April 12, 2017 BOARD OF COUNTY COMMISSIONERS ORANGE COUNTY, FLORIDA Y17-737-RM / ADDENDUM #2

ORANGE COUNTY CONVENTION CENTER HALL C DRIVEWAY IMPROVEMENT Bid Opening Date: April 18, 2017

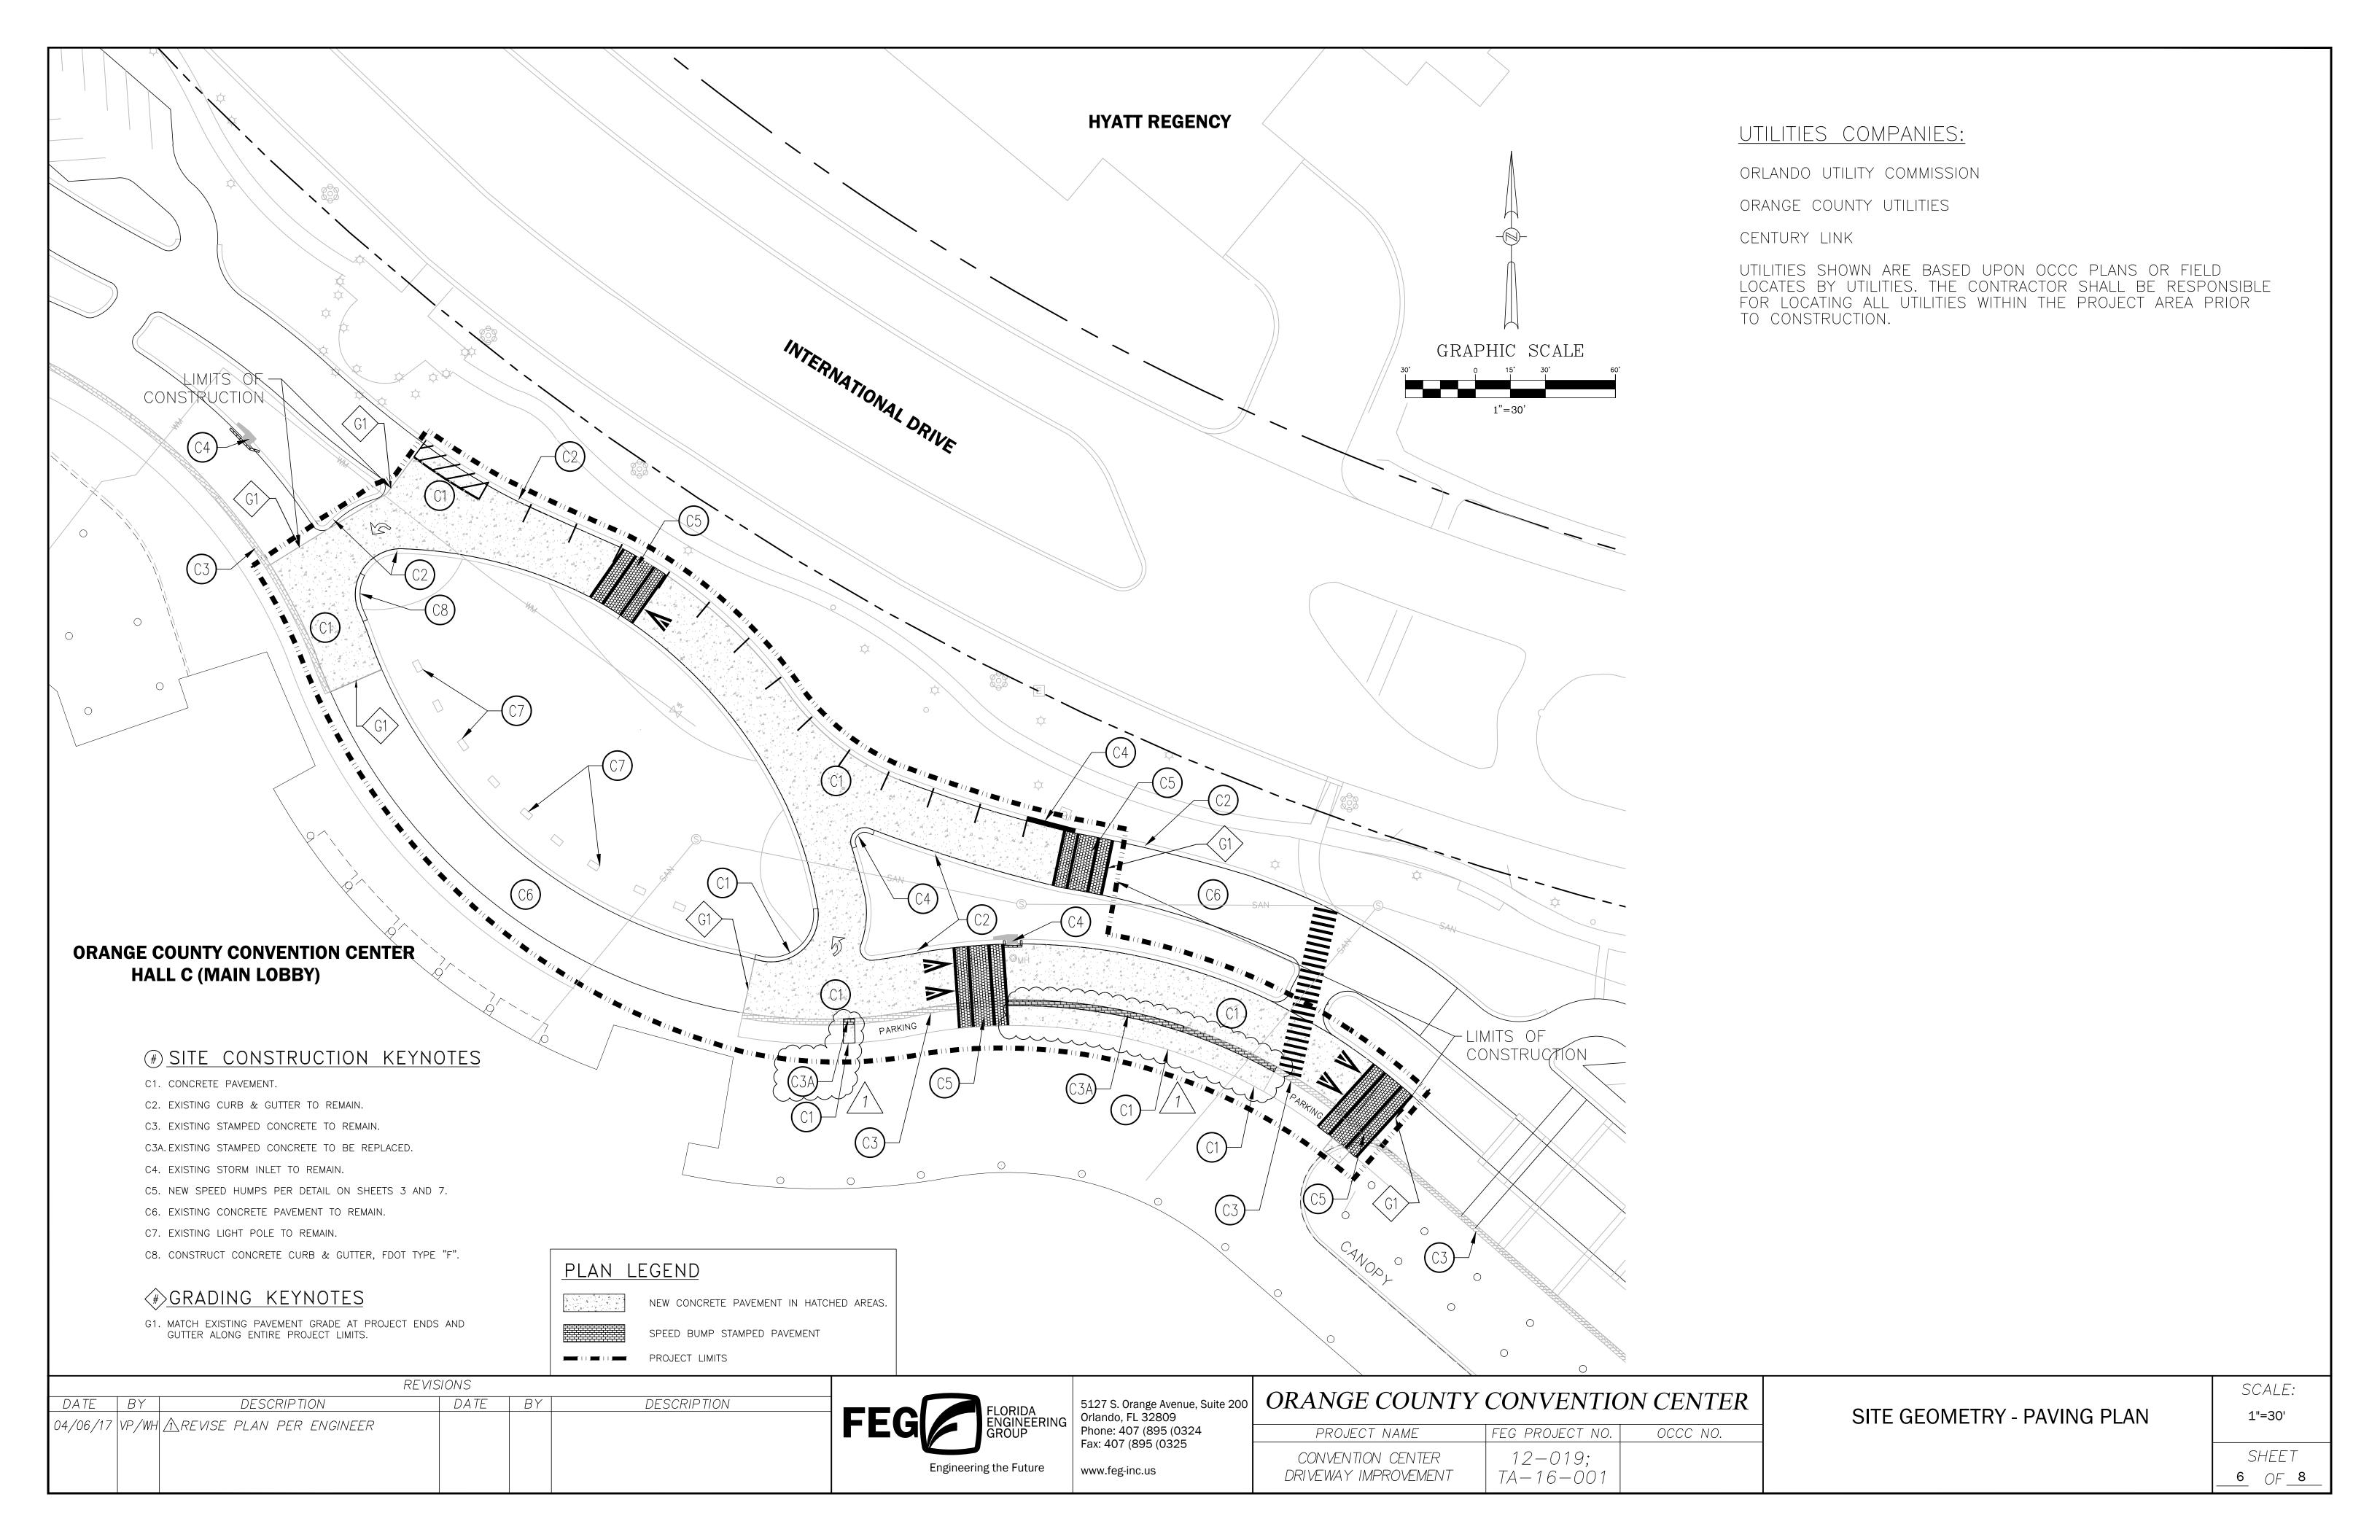
a. Added to Part G, paragraph 6. UTILITY COORDINATION:

The attached Test Hole Data Reports is available to bidders as information only and solely for convenience of the bidders. The COUNTY does not warrant or guarantee the accuracy or correctness of this information with respect to actual conditions. Refer to Part G, page G-4 Article 9: Contractor's Responsibility, Supplemental conditions.
